ARCHITECT'S SUPPLEMENTAL INSTRUCTIONS

PROJECT:	The Reserves at South Lake New Apartment Complex Grinnell, IA	Report No.	Three (3)
OWNER:	OPG South Lake Partners, LLC Dan Maximuk 234 N. Santa Fe Ave, Suite A Salina, KS 67401	Date	January 18, 2022
CONTRACTOR:	MCP Group 3501 SW Fairlawn Rd. Topeka, KS 66614	Architect's Proj No.	20-3118
		Contract For:	General Construction Mechanical, Electrical

IFA Plan Review

GENERAL NOTES:
 A. ALL DOOR HARDWARE TO BE LEVER TYPE LATCH SETS. PROVIDED & INSTALLED PER SPECIFICATIONS SEC. 8710. REF. SHEET A2.7 FOR BREEZEWAY DOOR SCHEDULE.

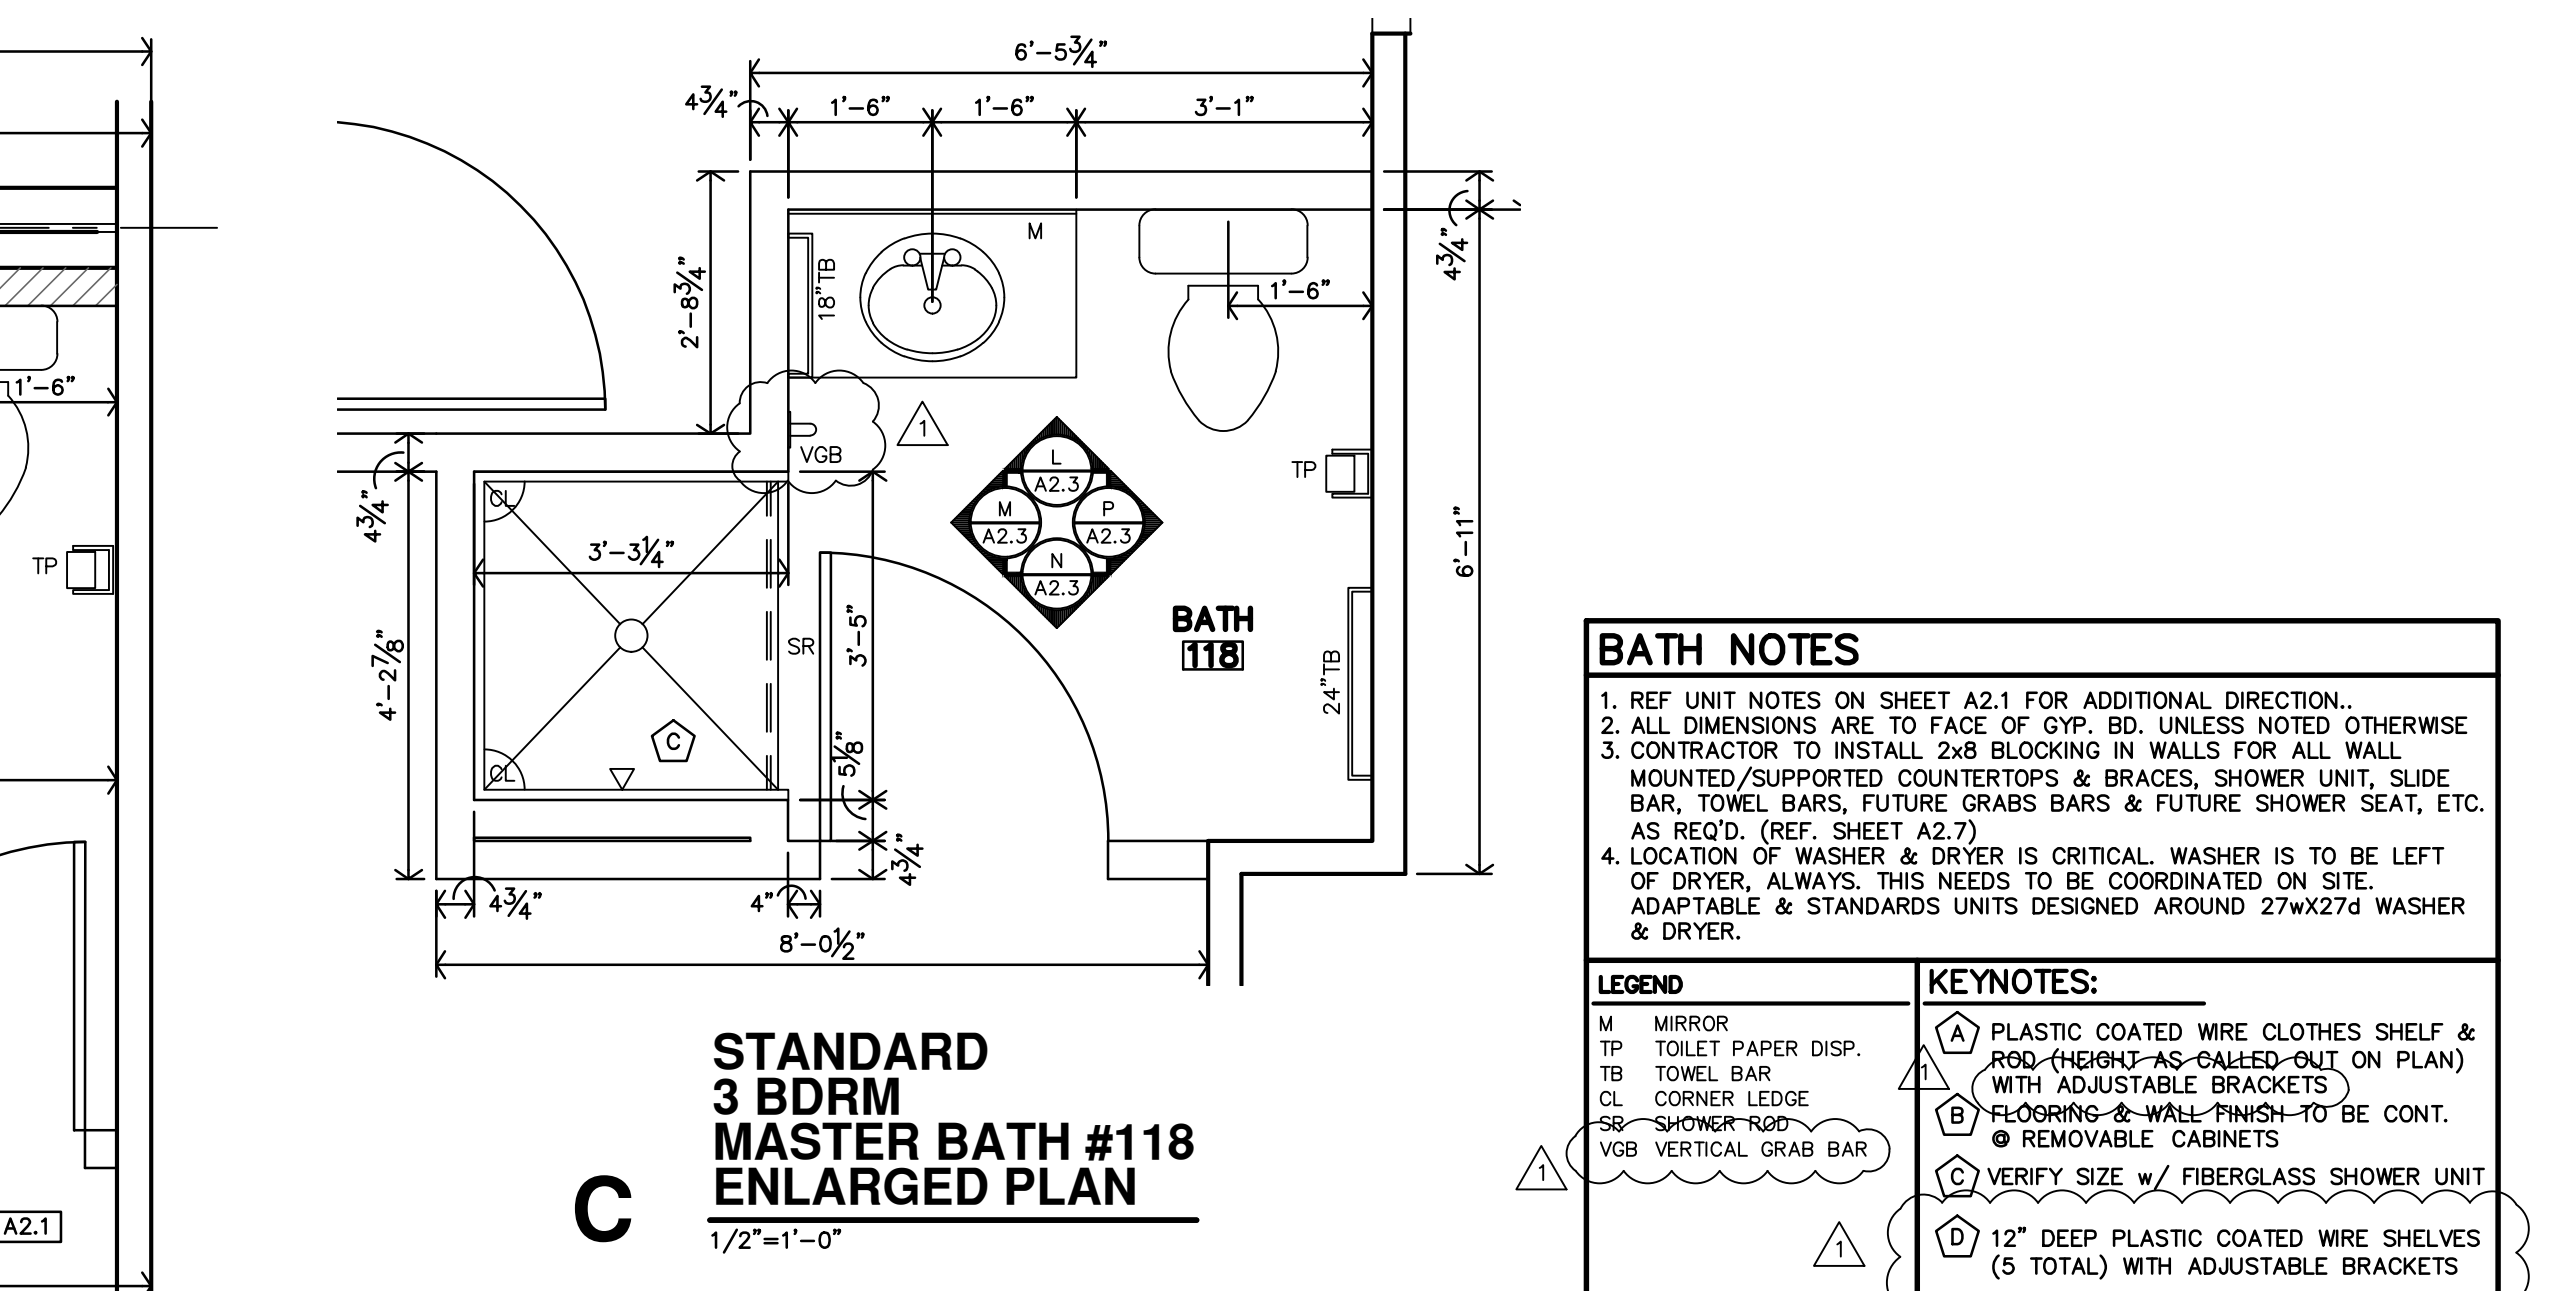
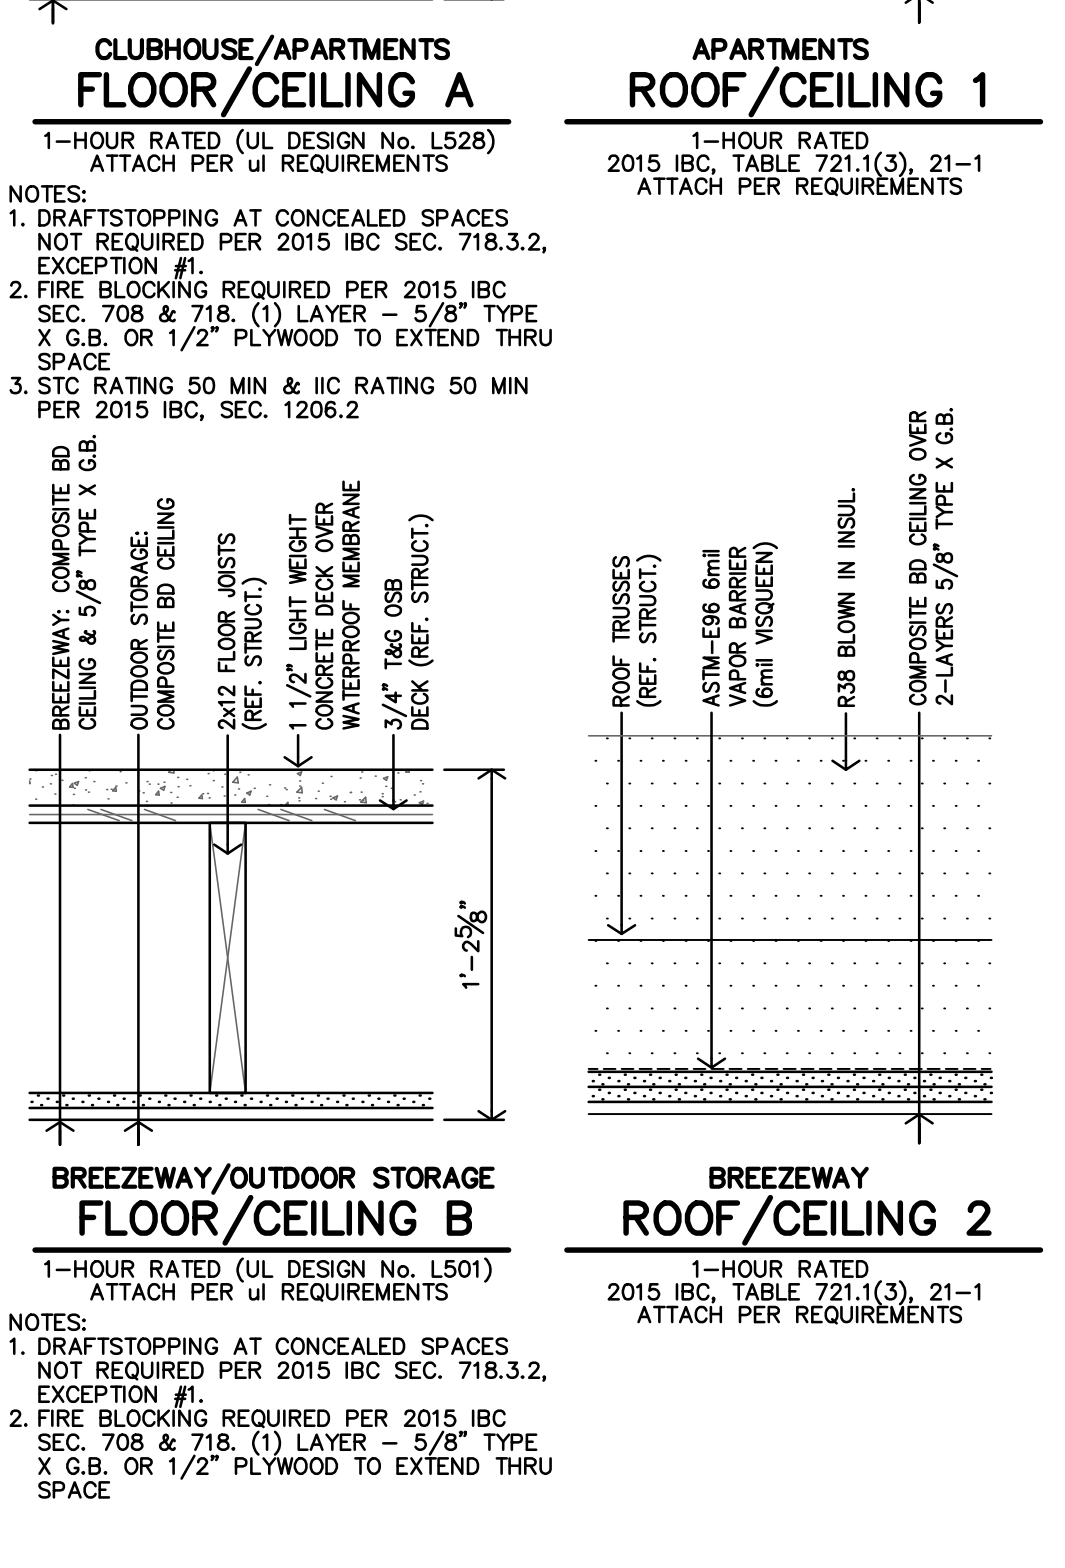
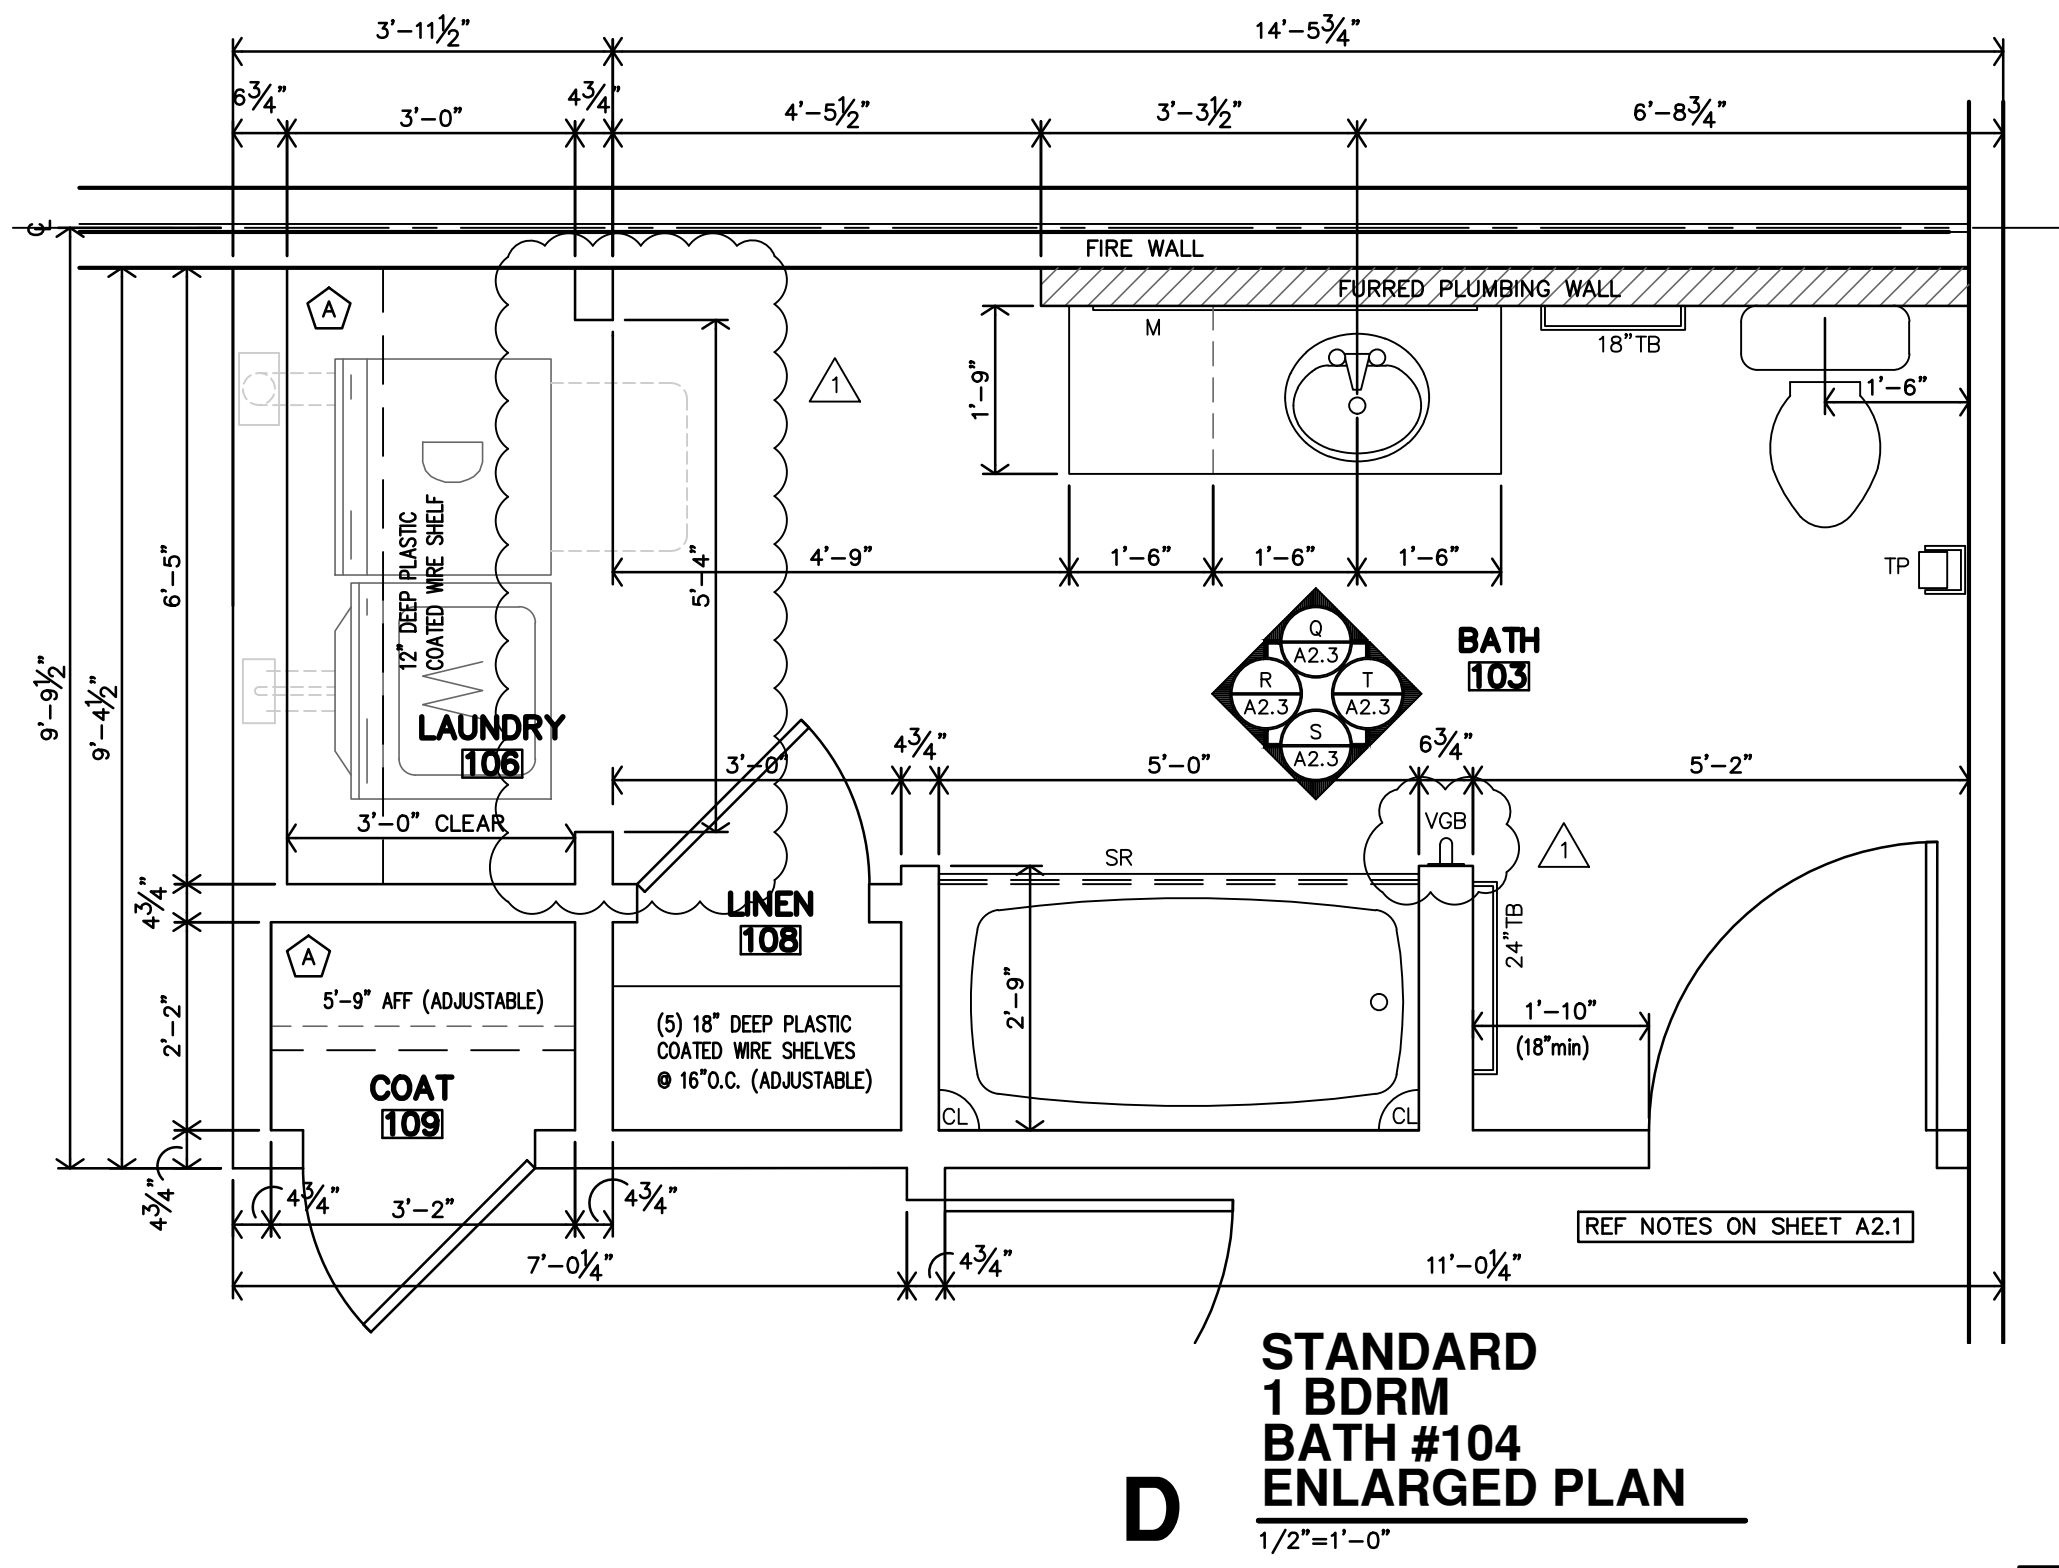
- ii. Sheet A2.2
 1. Apartment Interior Finish Schedule – Bath 103 & Master Bath 118 have been changed to Sheet Vinyl. Laundry 106 & Linen 108 have been changed to either Sheet Vinyl or Vinyl Plank (reference unit floor plans for material locations).

2. Apartment Door Schedule: Door 1 has been changed to a steel frame.
 - iii. Sheet A2.4 – Floor Plans A, B & C – Finished flooring material in Baths have been changed to Sheet Vinyl.

4. Unit entry doors must have steel frames. Schedule shows wood. The door schedule on Sheet A2.2 has been revised to show steel frames. The specifications have been revised as well. See attached.
